ADDENDUM NO. 1

August 24, 2022

Modify Atrium Lighting & Sprinklers – Mann Library - REBID
Addendum No, 1
August 24, 2022
Page 2

100% CONSTRUCTION DOCUMENTS
SUCF 161039 - Modify Atrium
Lighting & Sprinklers-Mann Library
 237 Mann Drive, Ithaca, NY 14853

D

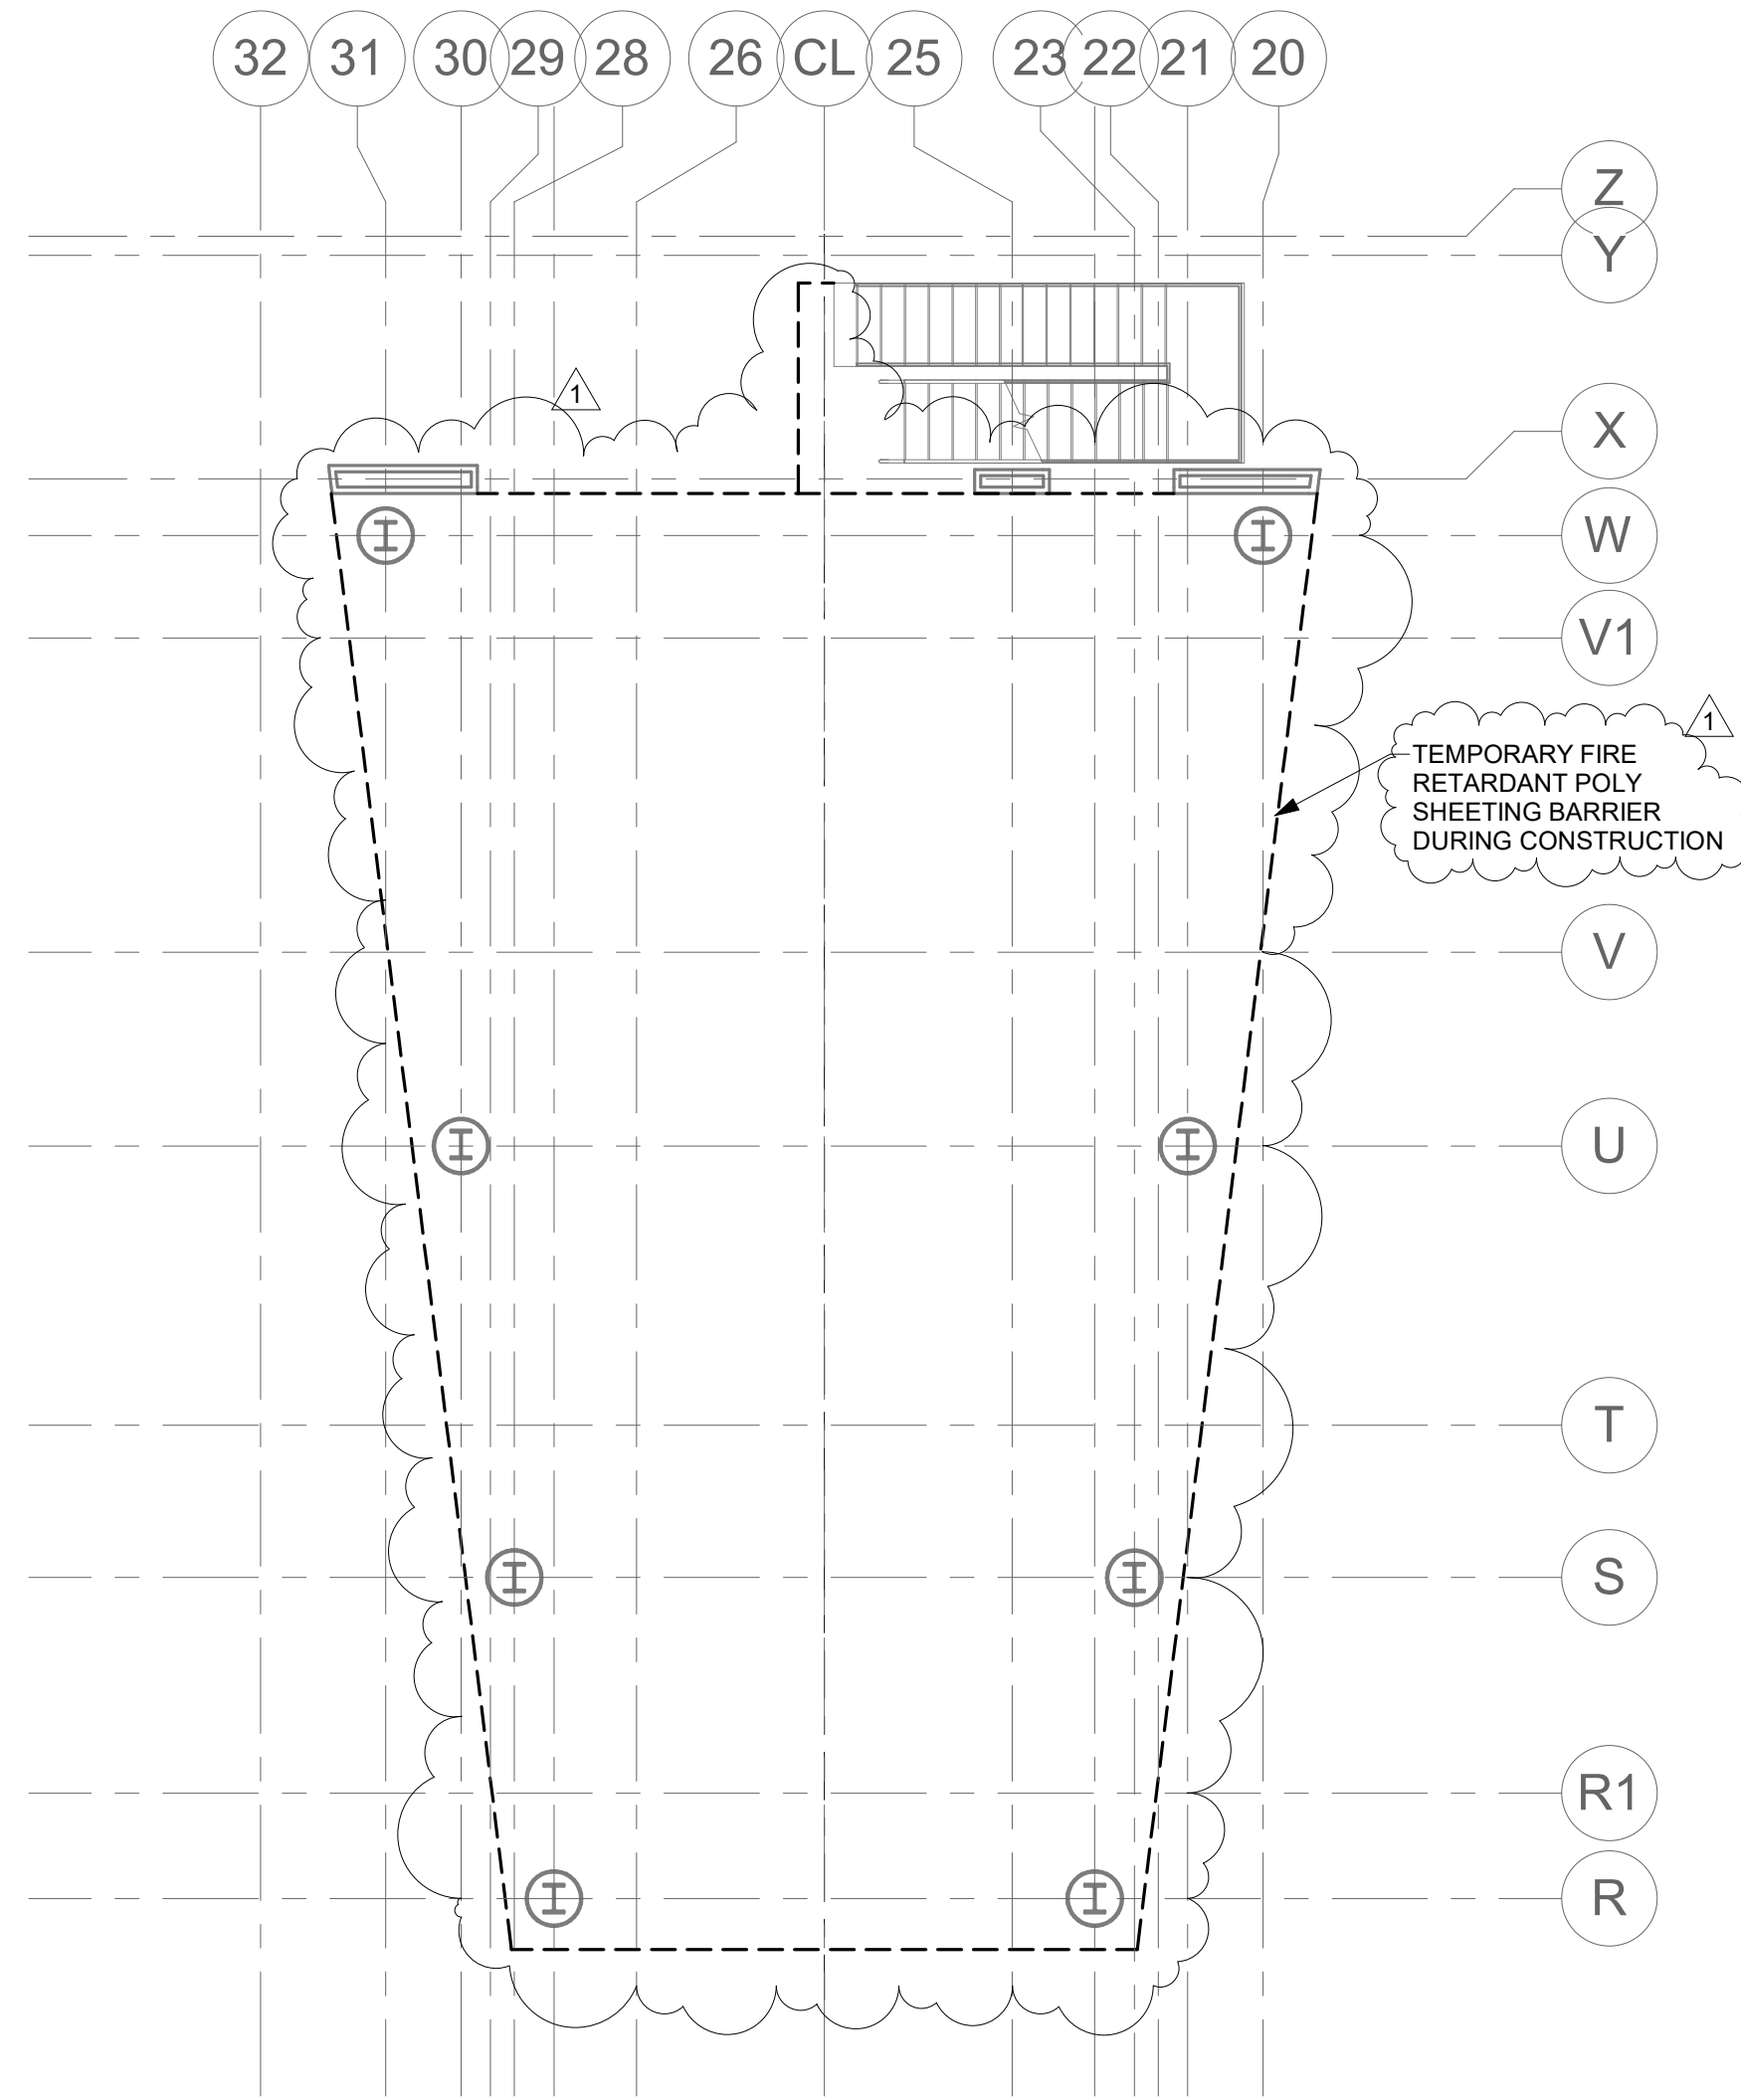
- NOTES:
1. INSTALL TEMPORARY FIRE RETARDANT POLY BARRIER DURING CONSTRUCTION TO LIMIT ACCESS AND PREVENT DUST FROM SPREADING. TAPE EDGES OF BARRIER AS REQUIRED TO PREVENT DUST MITIGATION.
 2. TEMPORARY FIRE RETARDANT POLY BARRIER AT ALL ENTRANCES TO STAIR 5 IS TO BE INSTALLED ONLY WHEN REQUIRED. STAIR 5 TO BE LEFT AVAILABLE FOR USE AT ALL OTHER TIMES.
 3. WINDOWS ARE TO BE CLEANED WHEN CONSTRUCTION IS SUBSTANTIALLY COMPLETE PRIOR TO REMOVAL OF SCAFFOLDING.
 4. MATS ON ROOF ARE TO MATCH PERFORMANCE OF EXISTING. QUANTITY AND LENGTH IS TO BE FIELD VERIFIED.
